Position Statement – Responses to OCAF Requests

The purpose of this document is to address the requests and objections raised by OCAF (Oxfordshire Countryside Access Forum) who have raised the following points with reference to proposed design. The OCAF written requests are in black type, EKFB responses are in blue.

2.2 Bridleway 225/4 objection

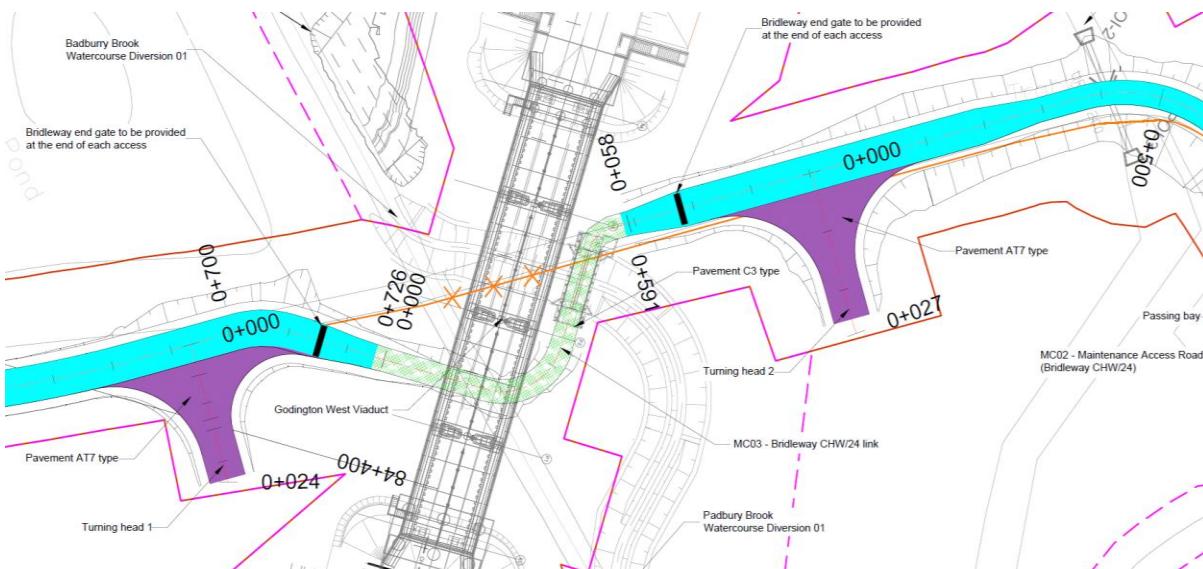
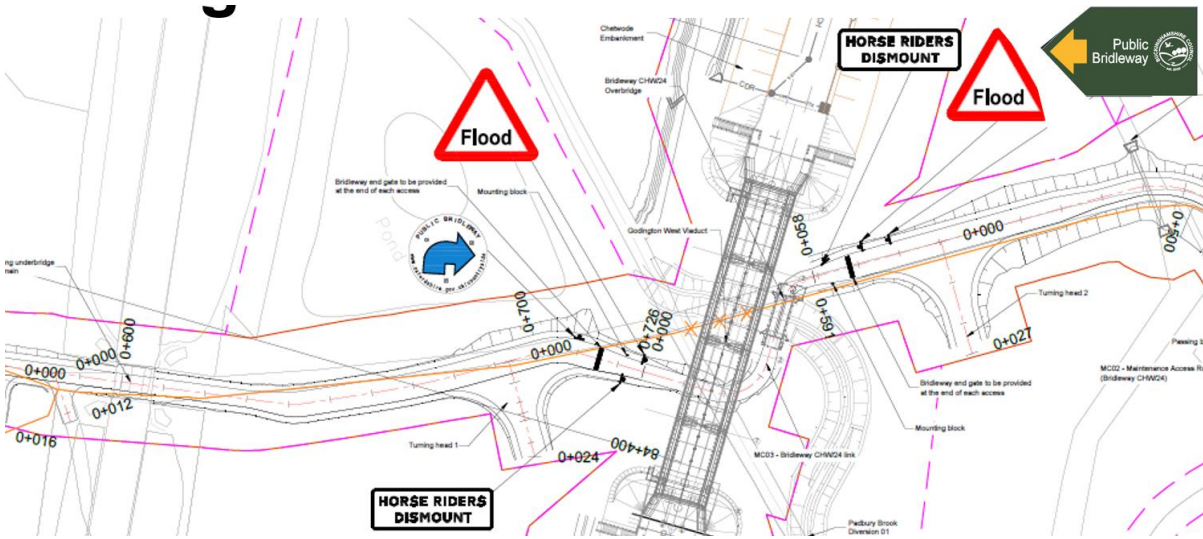
OCAF objects to the provision set out for Bridleway 225/4 requiring riders to dismount under Goddington West Viaduct as this is not considered a reasonable adjustment or provision. There needs to be two routes for riders, a non-dismount route that is made as flood resistant as possible, and for flood periods, a dismount route that includes mounting blocks at each end. Any underpass/subway route needs to consider the echo impacts on horses and include mitigation measures to reduce these to an acceptable level. Lighting needs to be provided so that horses are not 'spooked' by either tunnel or echo issues. Surfaces must be flood/skid resistant.

Regarding providing two routes under the viaduct, HS2 and EKFB appreciate the concern and have carefully considered an alternative proposal by OCC. However, it has been deemed unsuitable for the following reasons:

- The additional route would not comply with HS2 standards with respect to flooding consideration and access. It would not be suitable for HS2, EKFB and ASC to design and construct a pedestrian/equestrian route that will knowingly flood multiple times a year, given that there is a standard compliant solution available. Furthermore, the lowered ground will be more likely to maintain standing water and the depth of water will not easily be perceived by pedestrians. This will create an increased safety risk to all users.

- To achieve a 3.4m clearance it would be necessary to lower the ground by more than one meter. This would create a localised depression and the lowest point outside of the watercourse. Considering the necessary clearance of excavations from the pier foundations, the available width at the bottom of this lowered area would be no more than 1.25m. This would require a departure therefore this would be favouring a non-compliant design over the current fully compliant design.

- This alternative proposal has been considered an additional alternative route, which in effect doubles the resources, cost and time to provide at the tax payers expense, even though the current proposal is fully compliant to the standard CD143/DMRB which covers equestrian users. The cost attributed to this additional provision would be solely for mitigating the need for a relatively low number of equestrians from needing to safely dismount and mount at the mounting block facilities provided. Furthermore, there is no guarantee that they would use this alternative route even if it is not flooded. This is deemed not As Low As Reasonably Practicable (ALARP) given the risk

Bridleway 225/4 passes beneath the proposed Goddington West viaduct, and for reasons previously stated above there are no intentions to provide an underpass, or alternative design or route.

2.3 Bridleway 213/4 and Wildmore Farm – request

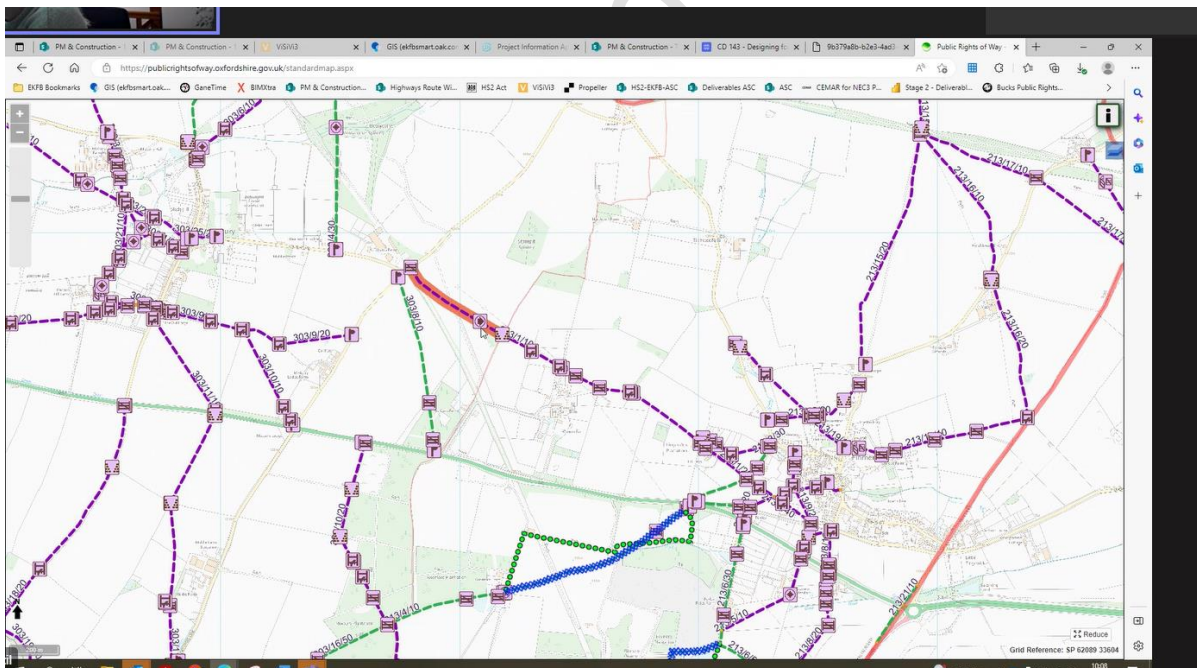
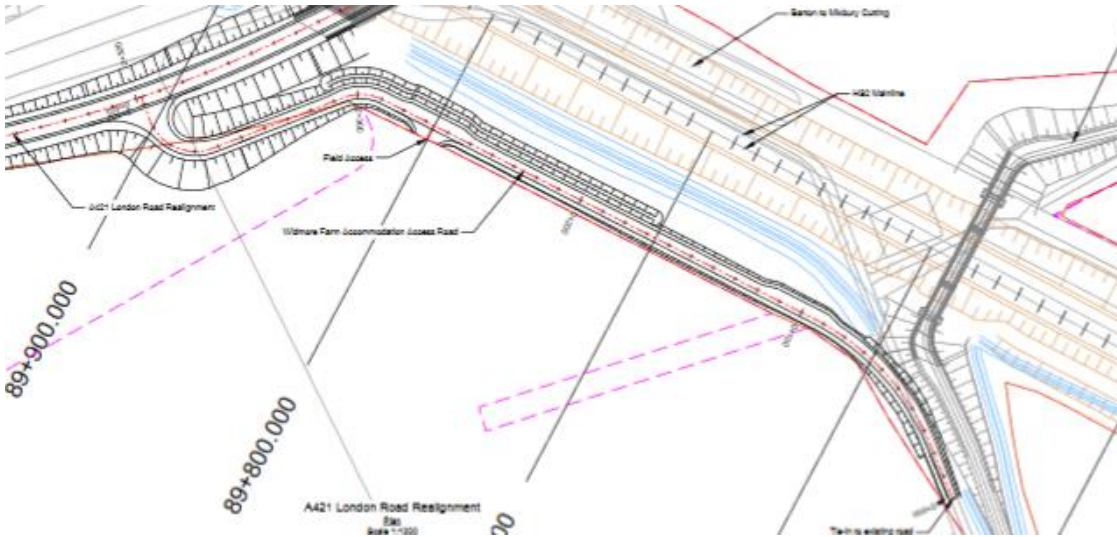
OCAF requests that the bridleway 213/4 realignment onto a new overbridge is combined with a bridleway alongside or along the Wildmore Farm access road to give access to bridleways 213/4 and 303/8. This should include a non-motorised user crossing facility for the A421. If this isn't possible then footpath 303/7 and 213/1 need upgrading to bridleway. This is to provide connectivity away from the noise and visual impact of HS2.

The Wildmore Farm Accommodation Access Road is a farm access located in Barton to Mixbury Cutting and is a private access. It provides a connection between the realigned A421 London Road and the existing Wildmore Farm

Access Road. The previous PRoW network did not offer connectivity across the A421 in this location, the access road simply serves to provide private access to Widmore farm. Therefore, this access road has not been designed for use by non- motorised users. Furthermore, there is no current, nor has there previously been a provision for non-motorised users crossing over the A421. For HS2 to provide a NMU suitable access to the edge of the A421 and onwards to bridleways 213/4 and 303/8 would require a fully developed strategy by the local authority for how it proposes to make ongoing access arrangements for non- motorised users. To our knowledge no such proposal exists and so it would not be prudent for HS2 to provide such a facility. The A421 is a busy road and introducing additional crossing points risks the safety of both pedestrians and road users. Summary of the traffic flows on the A421 is indicated in the table below:

The design has already passed through the schedule 4 consent process and has been approved.

The Local Authority, Oxfordshire County Council (OCC), as key stakeholder has been involved and informed of the development of the detailed design. During the process OCC hasn't raised the subject of increased connectivity for non-motorised users as an ambition for this area and hasn't requested an upgrade of the Widmore Farm access from accommodation access to a shared accommodation access and bridleway or any non-motorised user provision on the A421 London Road.

2.4 Featherbed Lane and Footpath 303/7 – request

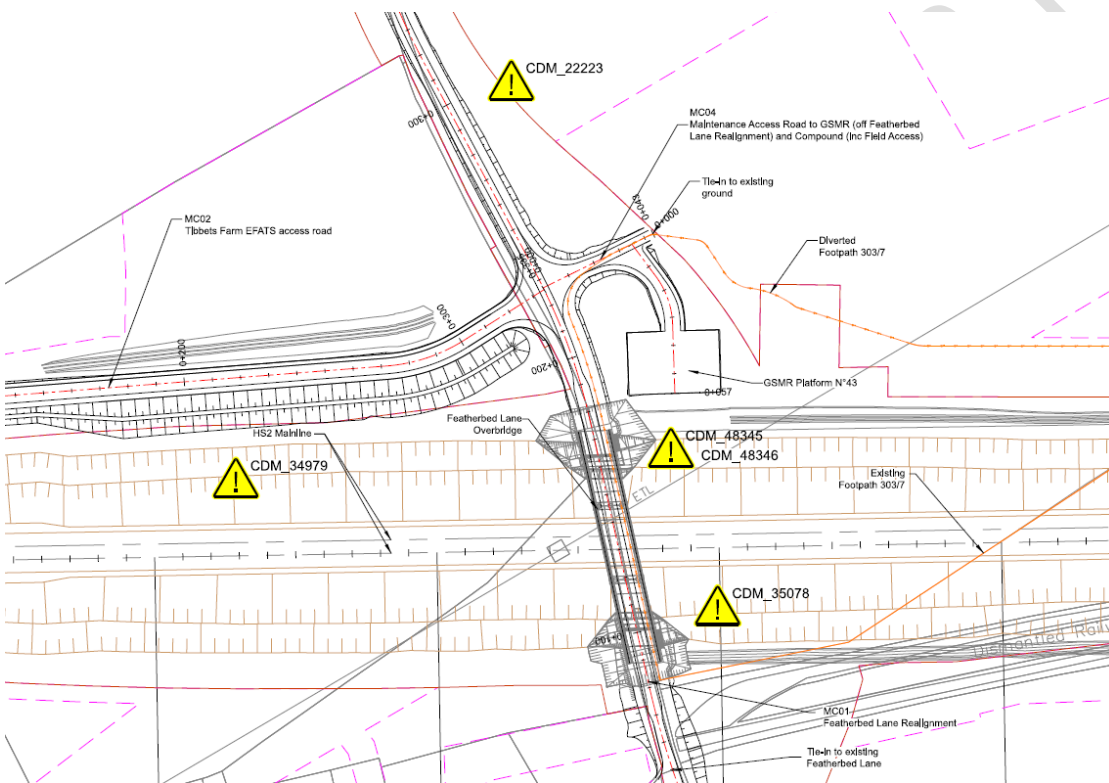
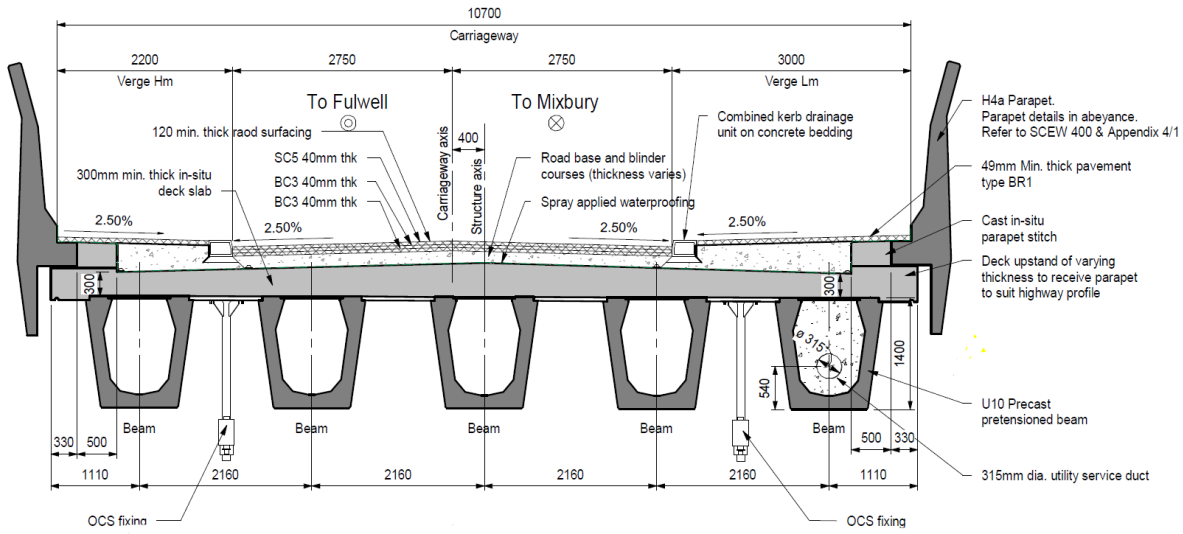
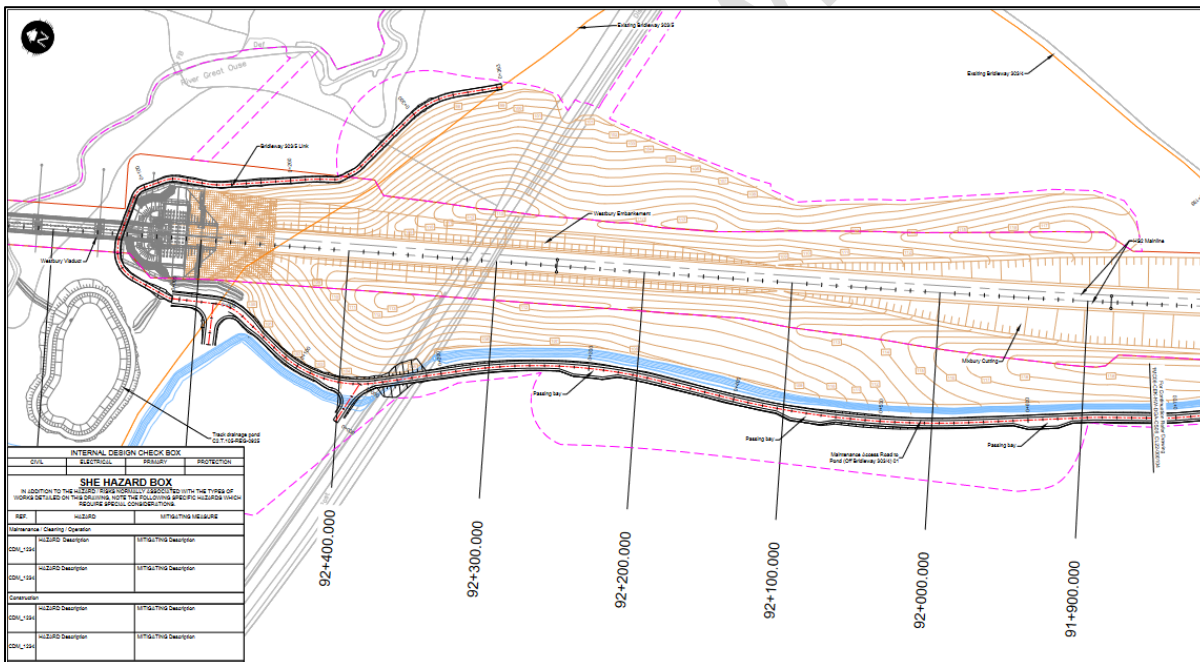
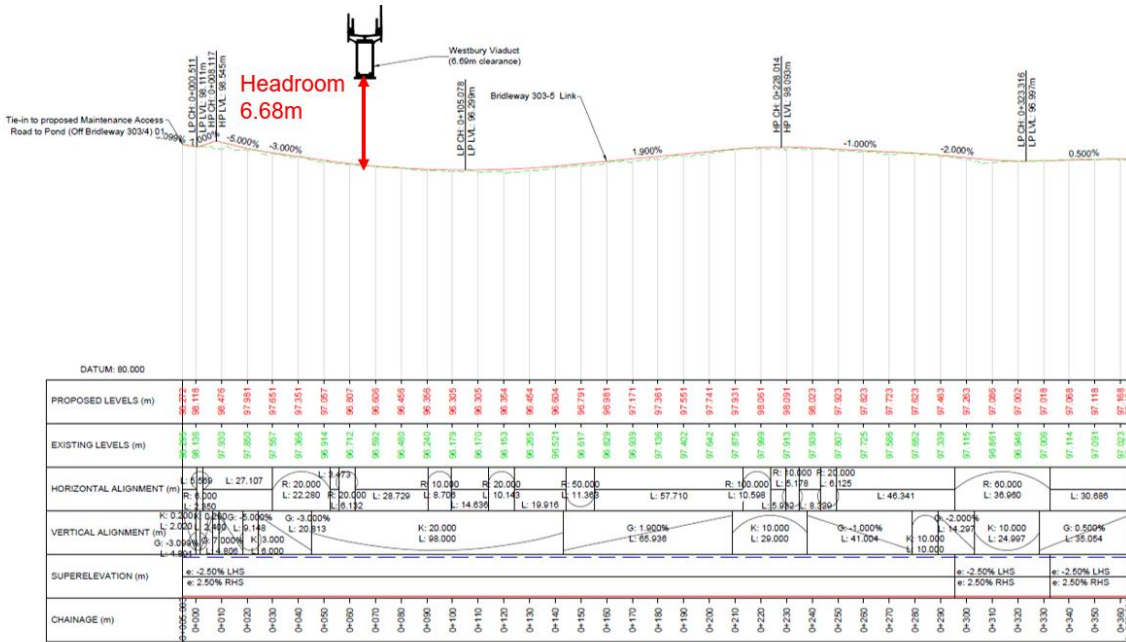
OCAF requests Featherbed Lane to be provided with a shared use bridleway instead of footway along Featherbed Lane, or a footway designated for cycle and horse use. This will enable connections to Tibbets Farm bridleway and Fulwell bridleway.

Featherbed Lane Realignment is classed as a single carriageway located in Barton to Mixbury Cutting and provides a connection between the severed existing Featherbed Lane on the east and west side of HS2 mainline.

We only propose to divert Footpath 303/7 using the proposed overbridge. Below is the proposed cross section on the bridge.

During pre-app meetings OCC has requested a review of our proposed AC14 surfacing to footpath paving to ensure suitability for equestrian use.(currently under review by DD team).

2.6 Footpath 308/13 – clarification and request

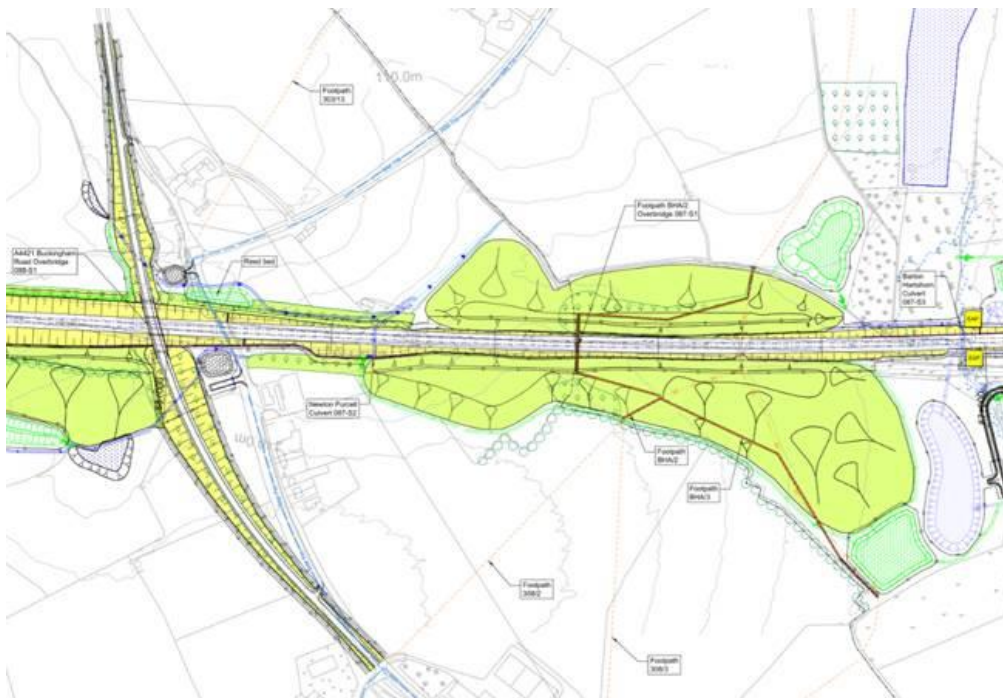
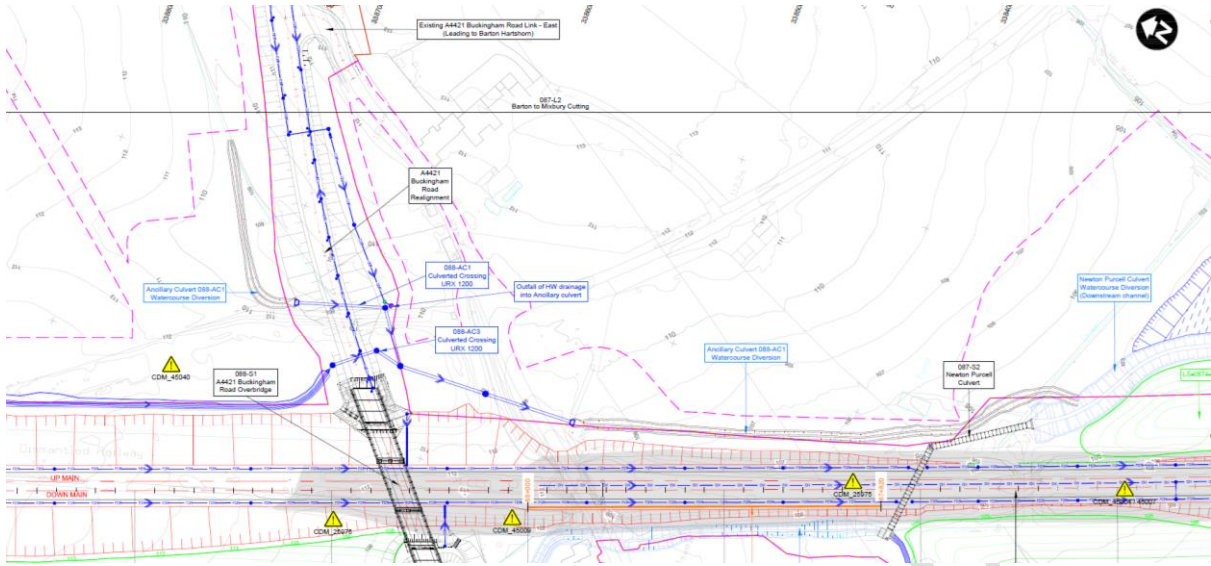
OCAF requests clarification on proposals for connecting Footpath 308/13 to other paths and negotiating the realigned A4421. There needs to be a connection provided to bridleway 308/7,

footpath 308/1 and footpath 308/2. A footway/cycleway is required along the A4421 or an underpass on the old A4421 road.

Footpath 308/13 is not impacted as shown below and is connected to existing A4421 link that is connected to the new A4421 diversion.

Bridleway 308/7, Footpath 308/1 and 308/2 are not impacted by the HS2 project and connections between them are as existing.

There is no provision of an underpass under the existing A4421 road or cycleway along the A4421.

It is proposed that the southern verge will be used as a footway up to the existing road link – east that will allow connection to the 308/13 users along the realigned A4421 Buckingham Road. During the development of the detailed design, OCC as a key stakeholder hasn't requested a shared footway/cycleway along the A4421. (A4421 is consented under Sch4)
